Illinois Tollway Standard Drawing Revisions

Section H		Roadway Lighting	
Standard	Modification Summary	Effective: 03-01-2024	
H1-12	LIGHT STANDARD FOUNDATION		
Sheet 1	Revised the bolt projection dimension from 3-1/3" to 2-1/2". Added detailed notes to Note 1 to address the grading changes surrounding the light standard foundation.

LIGHT STANDARD FOUNDATION DETAILS - HELIX
(GROUND MOUNTED UNITS)

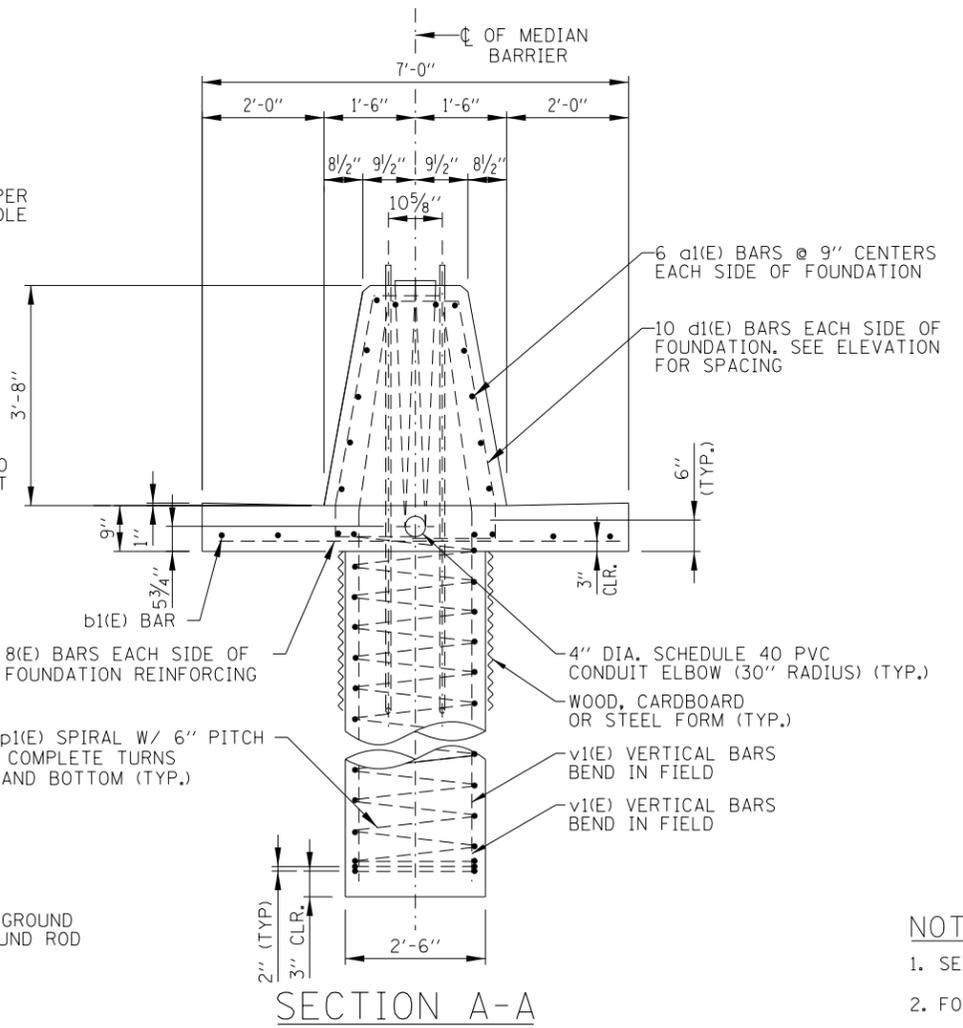
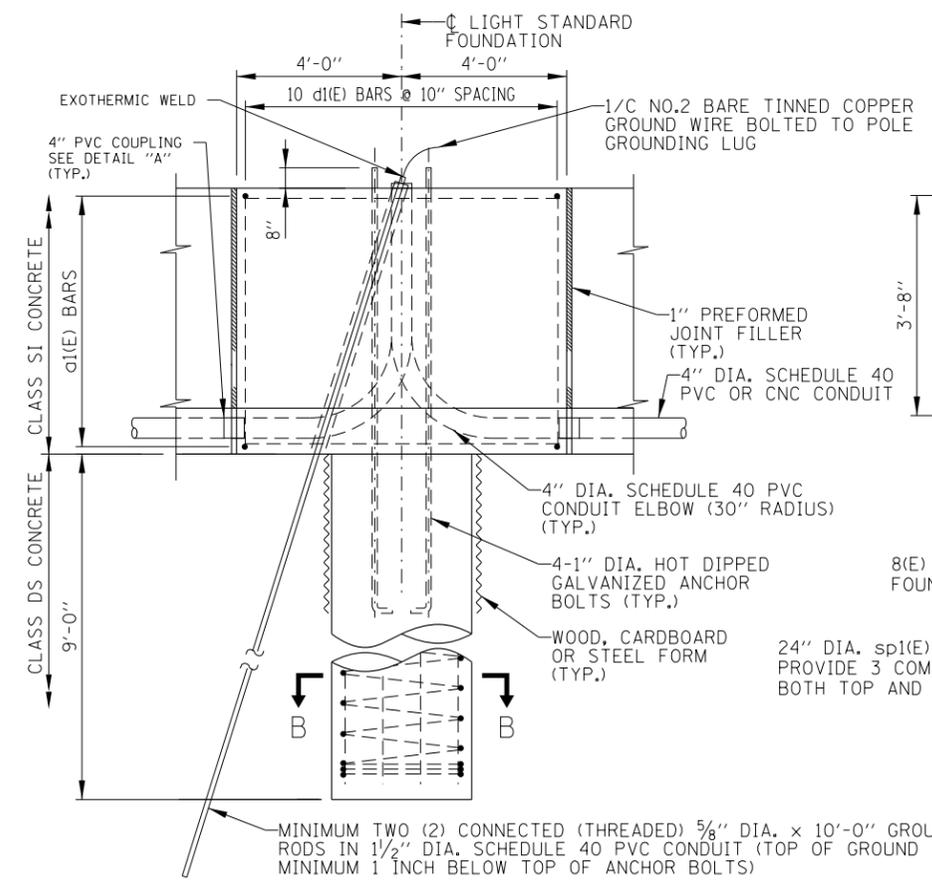
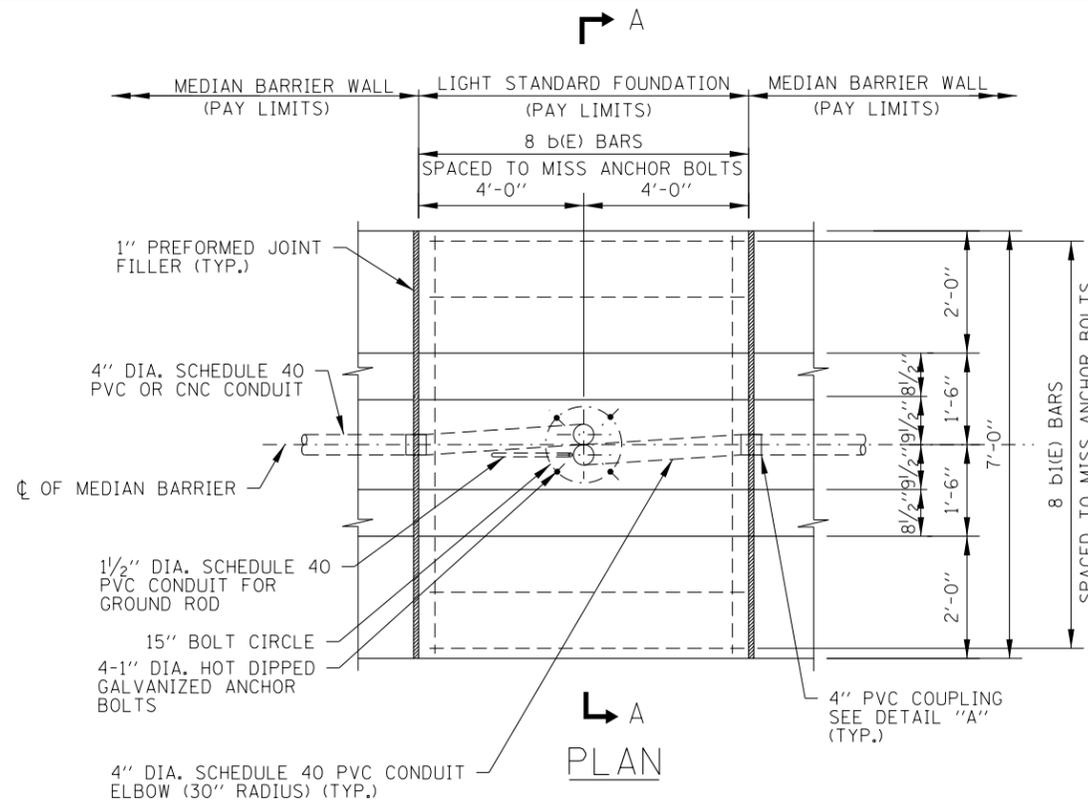
Sheet 2	Revised the bolt projection dimension from 3-1/3" to 2-1/2" max or as needed. Added note of reference to hardware and attachment details. Added reference to the graded aggregate pad at finished grade. Revised the description of the steel helix mounting plate.

LIGHT STANDARD FOUNDATION DETAILS - MEDIAN BARRIER
(TYPE 1 CENTERED CAISSON, 44" BARRIER)

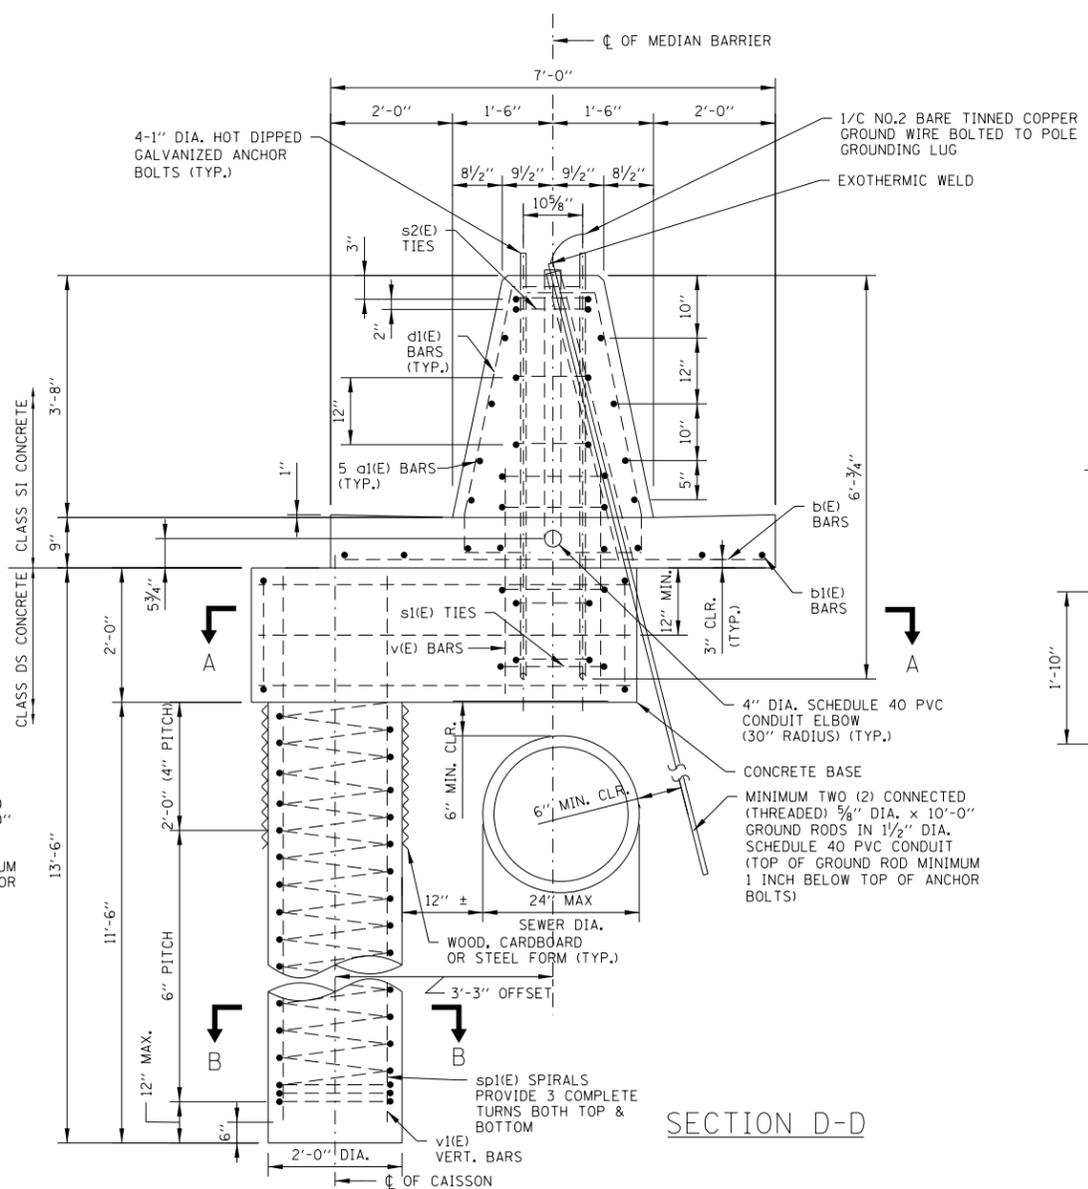
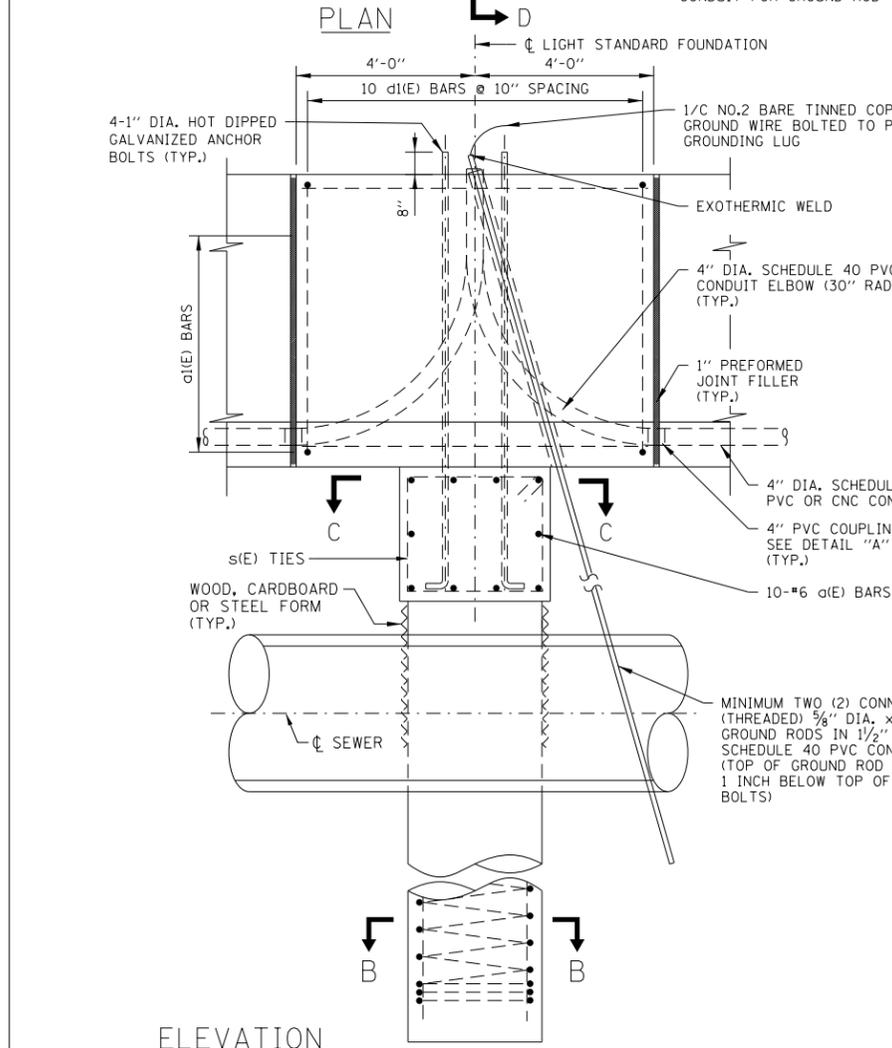
Sheet 3	Revised the dimension to 44-inches from 42-inches within the Light Standard Foundation detail title.		
Sheet 4	Revised the dimension to 44-inches from 42-inches within the Light Standard Foundation detail title.

LIGHT STANDARD FOUNDATION DETAILS - MEDIAN BARRIER (TYPE 3 STRADDLED CAISSON, 44" BARRIER)

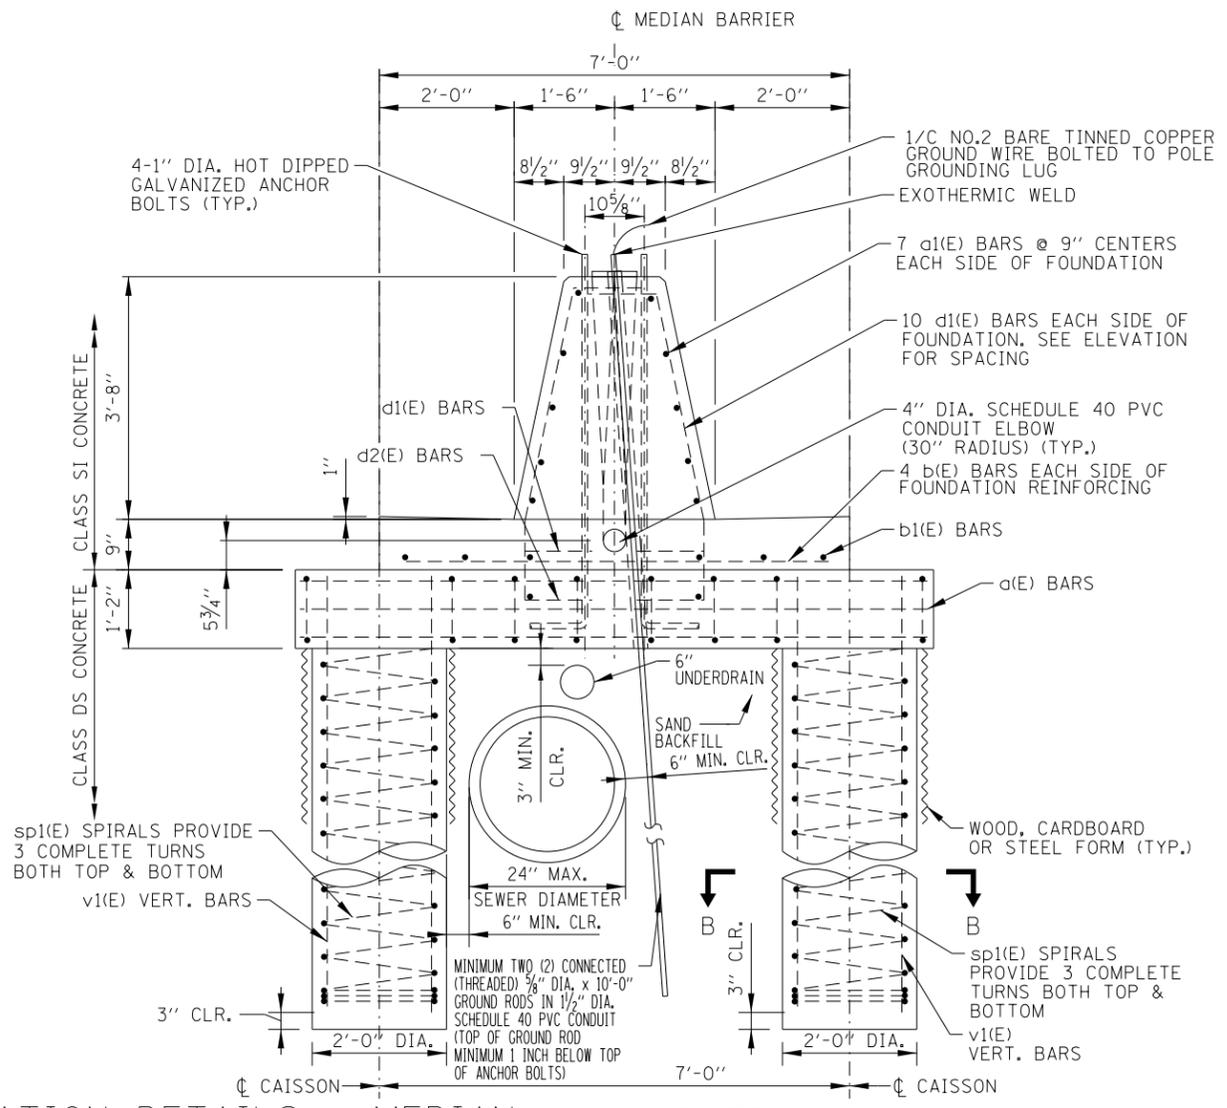
Sheet 5	Revised the dimension to 44-inches from 42-inches within the Light Standard Foundation detail title.		
Sheet 6	Revised the dimension within the Light Standard Foundation detail title to 44-inches from 42-inches.

LIGHT STANDARD FOUNDATION DETAILS - GRADING W/ FORESLOPE
(GROUND MOUNTED UNITS)

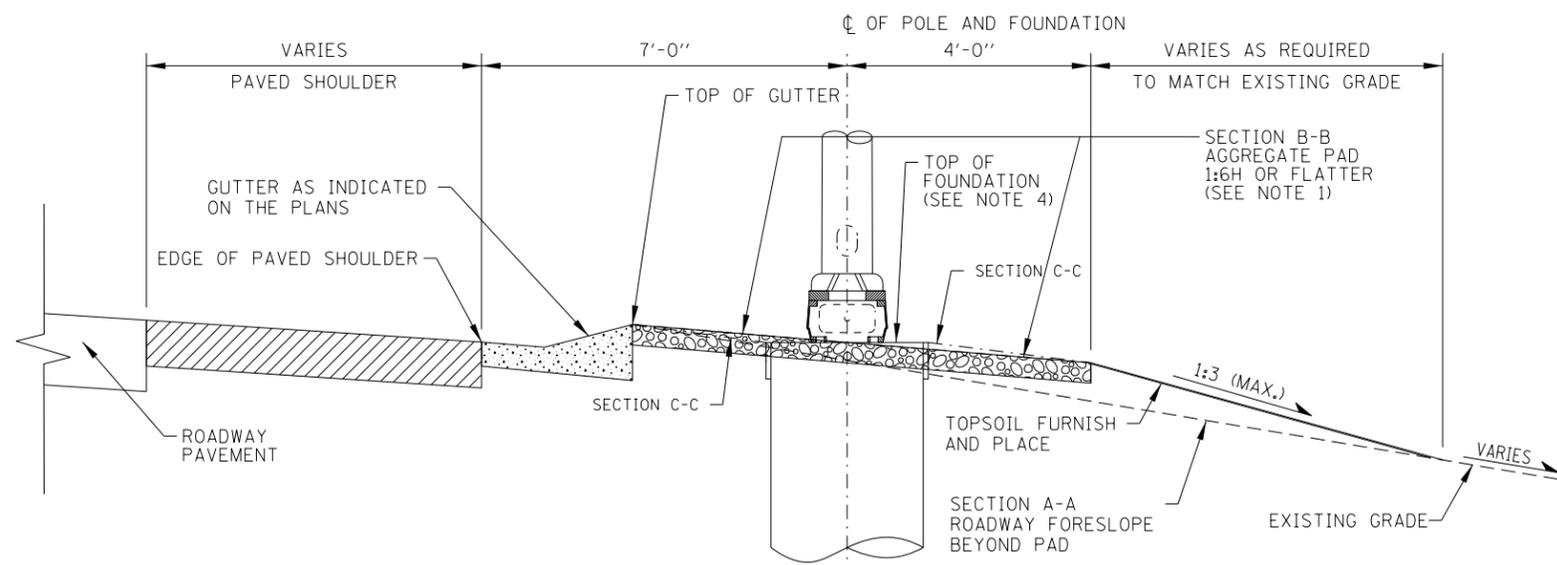
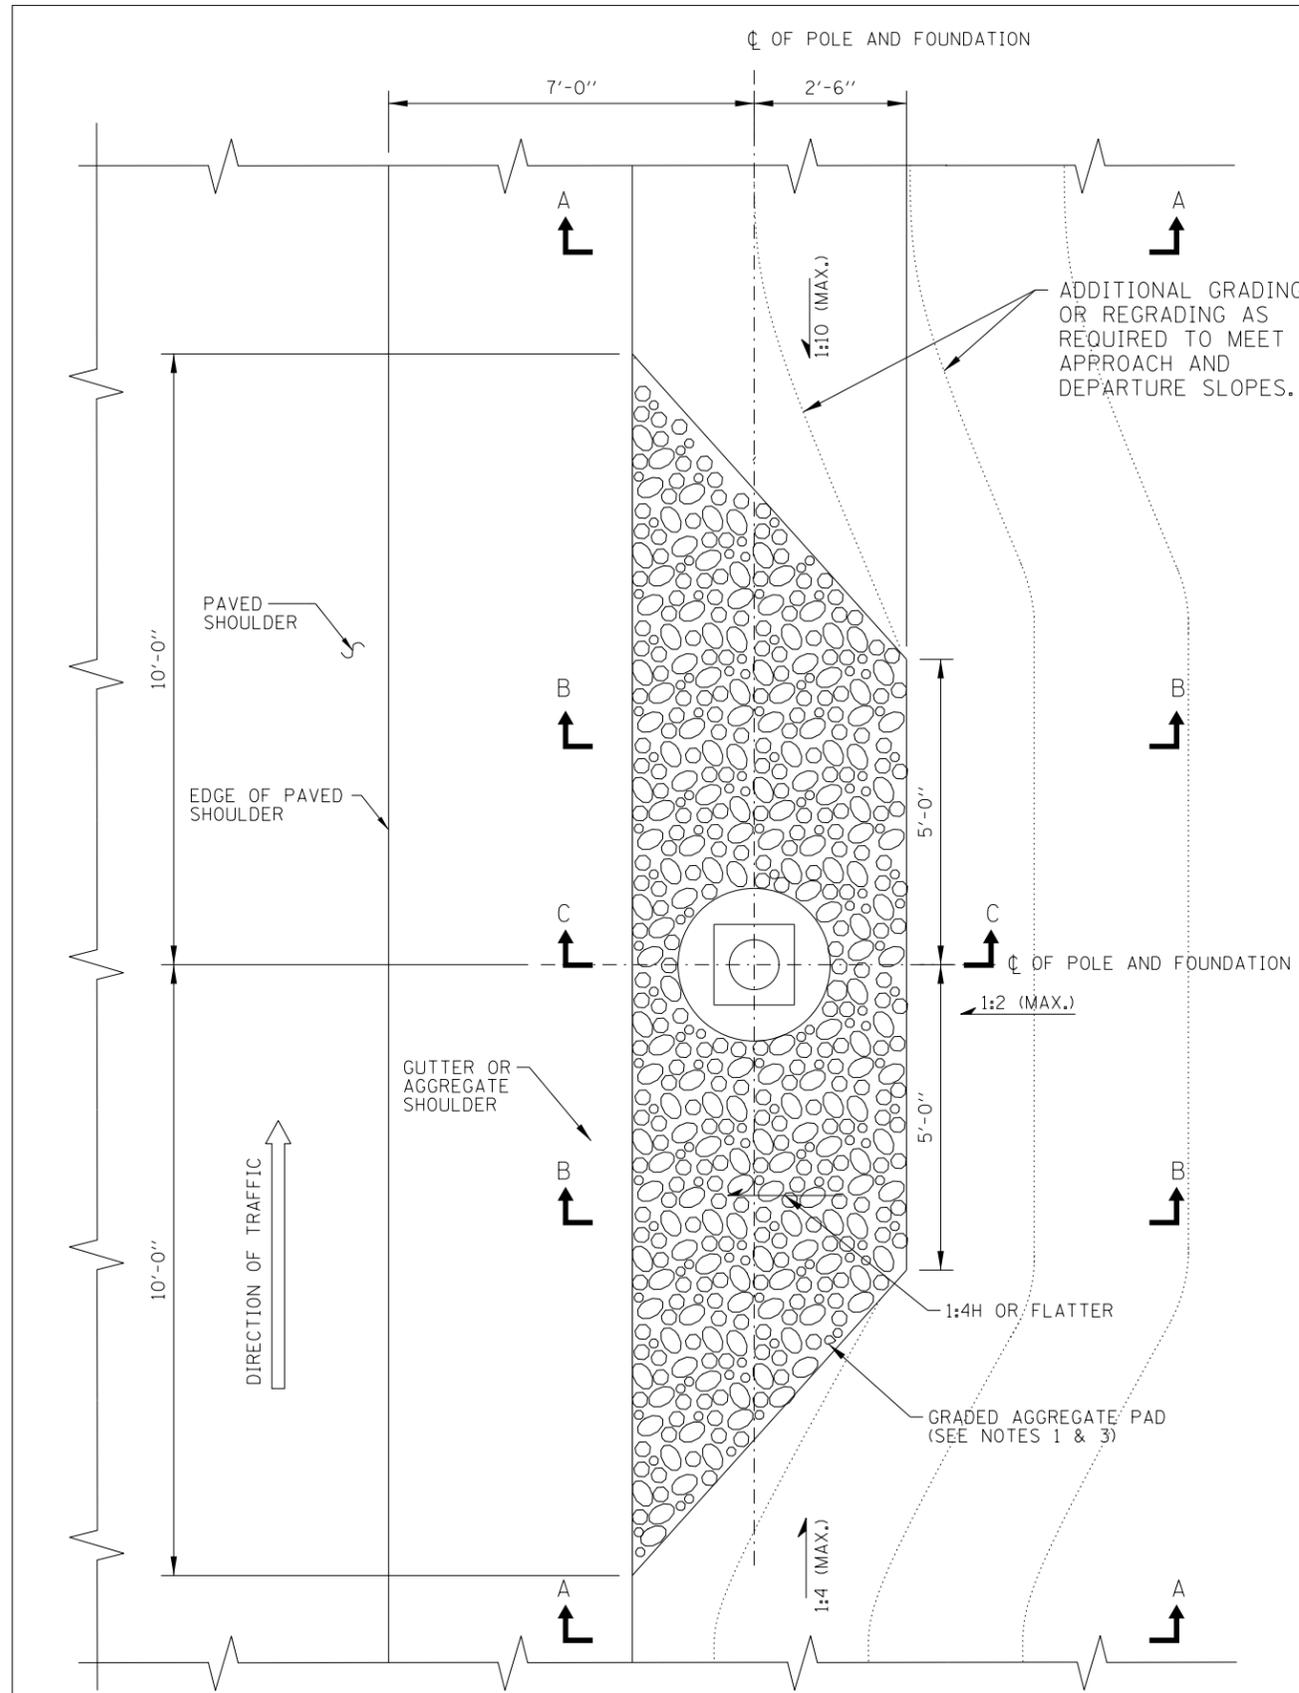
Sheet 7	Revised all references to aggregate from level. Revised grading details to account for slope adjustments.		
Sheet 8	Revised all references to aggregate from level. Revised grading details to account for slope adjustments.
